Hydrol. Earth Syst. Sci. Discuss., author comment AC2
<https://doi.org/10.5194/hess-2020-670-AC2>, 2021
© Author(s) 2021. This work is distributed under
the Creative Commons Attribution 4.0 License.

Authors answers to RC2

Author comment on "Machine-learning methods for stream water temperature prediction"
by Moritz Feigl et al., Hydrol. Earth Syst. Sci. Discuss.,
<https://doi.org/10.5194/hess-2020-670-AC2>, 2021

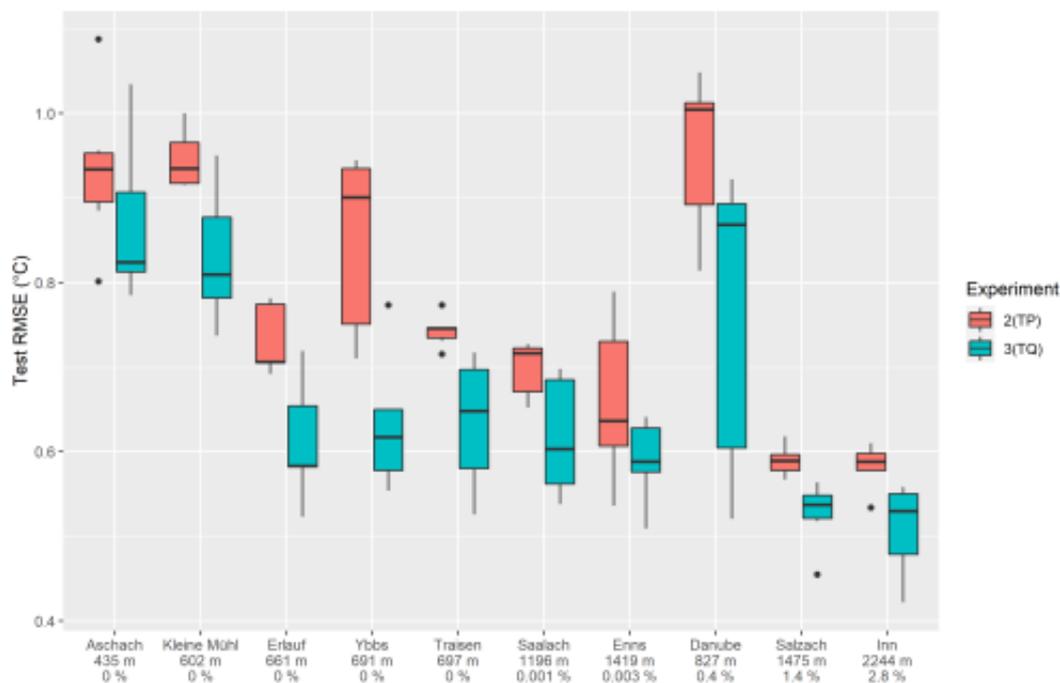
The authors discuss the importance of snow/glacier cover in the perspective of climate change (CC) application (I discuss CC below). However, this is not discussed for the application done in the paper. First, I suggest to add in Table 1 the mean catchment elevation and percentage of glacier cover in the catchments in order to allow a quick overview of the contribution of glacier and snow melt we can expect on each catchment.

These points are highly interesting and will be addressed in more detail in a subsequent publication, which is currently in preparation. To answer your questions here, we computed the percentage of glacier and perpetual snow cover from the CORINE Land Cover data 2012 and the mean catchment elevation from the EU-DEM v1.1 digital elevation model with 25x25 m resolution, which we will include in Table 1 of the revised manuscript. The following table shows the corresponding values for all study catchments:

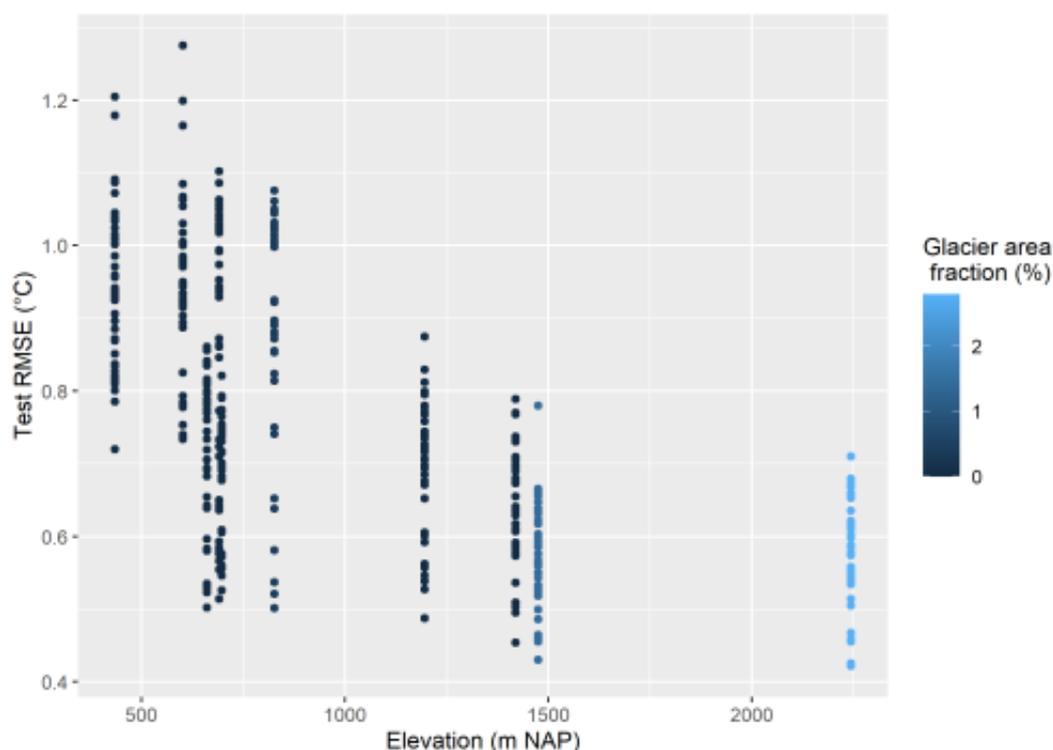
I would expect the TQ experiments to perform significantly better than the TP ones in catchment where snow plays an important role. Indeed, snow melt dynamic is captured in Q while I doubt TP experiments will be able to get it. This is difficult to see from Fig 4c and A1, so I would suggest to add further information about TP vs TQ comparison in high elevation catchment. Especially since the authors mention TP performance as an argument for usage in CC impact studies (lines 532 to 537).

We believe that these are important questions and we again want to refer to our subsequent publication for a detailed answer. To give an overview here, we analyzed the differences in TP and TQ performances depending on elevation and glacier cover. TQ generally shows a significantly lower test RMSE. The difference between TQ and TP performance at the same time does not show any changing patterns when evaluating high elevation catchments in our data. This is visible in the following figure, which contains test RMSE values for both experiments 2(TP) and 3(TQ) for all catchments. The catchments are sorted by elevation and glacier cover fraction, from left (low elevation, no glacier) to right (high elevation, glacier).

As you expected, there is a significant relationship between mean catchment elevation, glacier fraction and test RMSE. We tested this with a linear model using mean catchment elevation, glacier fraction in % of the total catchment area, total catchment area and the experiments as independent variables and test RMSE as dependent variable. This is illustrated in the following figure which shows test RMSE values and mean catchment

elevations for all experiments, with additional information of the glacier area.

We propose to add a sentence regarding the relationship between test RMSE and mean elevation in the results section 3.2 as proposed in the answer of the third comment.

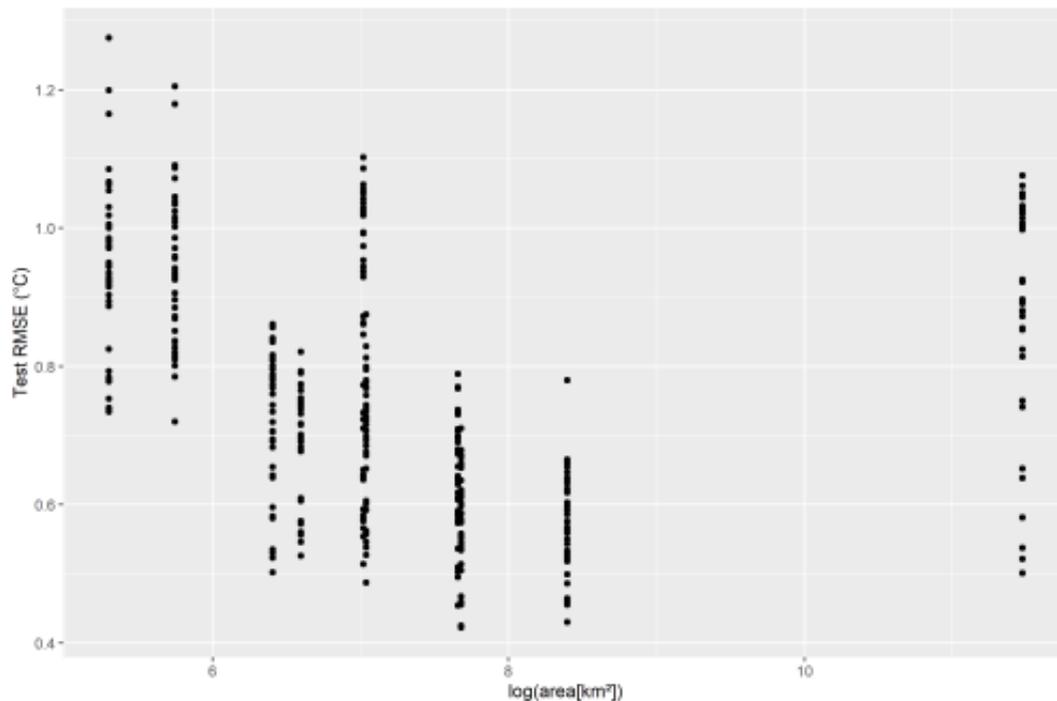
Catchment's size seems to have a clear influence on the results. Indeed, if we neglect the Danube catchment, Figures 4c and A1 show a reduction of RMSE and MAE with increasing catchment's size. This is not surprising since I would expect local scale effects, harder to capture in models, to be smoothed out when increasing catchments size, leading to an increase of the model performance. It could be interesting to replace catchment with catchment size in the linear regression for test RMSE, or use both, in order to really asses it (in any case this would mean a regression with both discrete and continuous variables). This size effect is currently not discussed (except for the Danube) while I think it should definitely be mentioned.

We agree, catchment size seems to have an effect on model performance. When substituting catchment with catchment area in the linear regression model for test RMSE, we find a significant ($p\text{-value} = 3.91 \times 10^{-4}$) influence. This is also visible when plotting test RMSE of all experiments together with the logarithm of the catchment area:

Overall, we agree that due to aggregation, local small scale effects on stream water temperature are smoothed out, making it easier to perform predictions based on catchment means. The fact that the Danube shows a reduced performance instead of an increased one for all models except RNNs, leads us to the conclusion that while larger catchments are easier to model, they need additional lagged information due to longer-term dependencies.

We propose to add the findings regarding catchment area, elevation and glacier cover in the results section 3.2 after line 460:

“The relationship between mean catchment elevation, glacier fraction and test RMSE was analyzed with a linear model using mean catchment elevation, glacier fraction in % of the total catchment area, total catchment area and the experiments as independent variables and test RMSE as dependent variable. This resulted in a significant association of elevation (p-value $< 2 \times 10^{-16}$) with lower RMSE values and catchment area (p-value = 3.91×10^{-4}) and a significant association of glacier cover (p-value = 9.79×10^{-5}) with higher RMSE values. Applying the same model without using the data of the largest catchment, the Danube, resulted in a significant (p-value = 2.12×10^{-11}) association between catchment area and lower RMSE values, while the direction of the other associations stayed the same.”

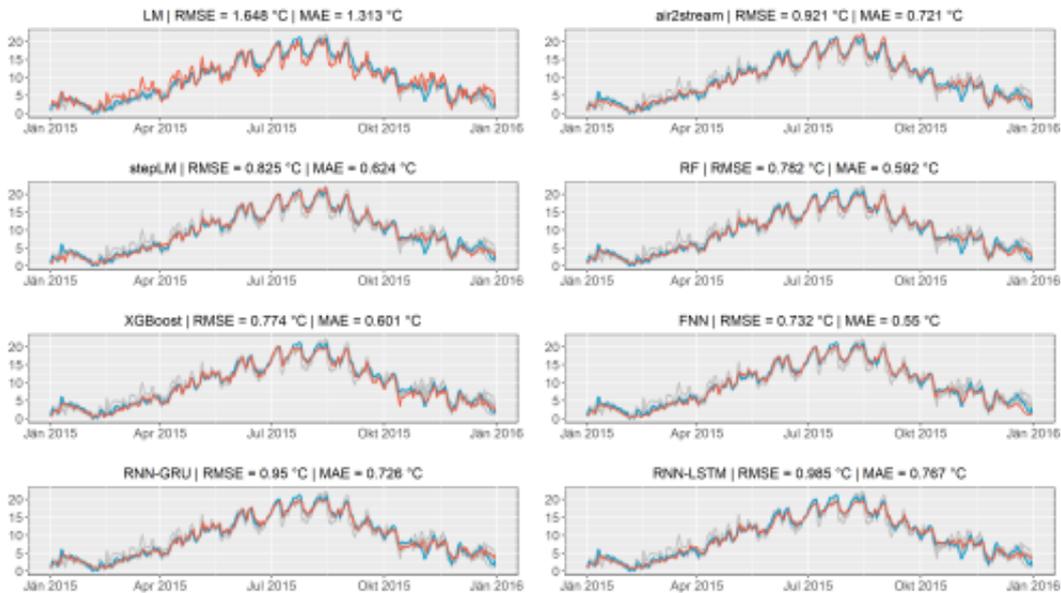
Finally, the training is done on really different time period lengths. The results seem to suggest that there is no correlation between length of the training period and RMSE. This difference in period length is not really discussed in the paper. In general, having similar training periods would be beneficial to really compare the models' performances across catchments. Indeed, with the data provided, we do not know if the differences observed across catchments are due to catchments' characteristics or to the training time period length. I imagine that the heavy computational time forbids to re-run all catchments using similar datas. However, a re-run on a single catchment with > 30 yrs of data, but using only 10 years as for the Enns, could be interesting to assess the impact of the length of the training time series on the results. Note that this question of length of the time series available for training is an important point for application perspective. Indeed, water temperature measurements network are usually quite recent (few decades), compared to time series available for discharge.

From the current results we assume not much difference in performance between a model using 30 years and a model using 10 years of data. Our results show that also short time series (6 years of training in all experiment 5 & 6 models) can produce state of the art results. It is nevertheless true that we do not know the data length threshold at which the model performance is significantly reduced. However, we believe that this threshold is highly dependent on the catchment and the main processes that are present in the catchment. We share your interest in these points and thank you for your suggestions. However, at this point we would like to kindly point out to the follow-up study we are currently working on.

As you mentioned, there is no apparent correlation between RMSE and the length of the training period in our results. Based on these results we conclude that the influence of the catchment is most likely larger than the influence of the time series length. However, we believe that, since the number of investigated catchments is limited, effects such as the relationship of time series length and model performance can not be estimated with certainty. There may be a strong correlation between time series length and RMSE in certain types of catchments (e.g. small alpine catchments), but finding these relationships is not possible with the given study setup. Thus, we would like to refrain from making assumptions we cannot yet proof.
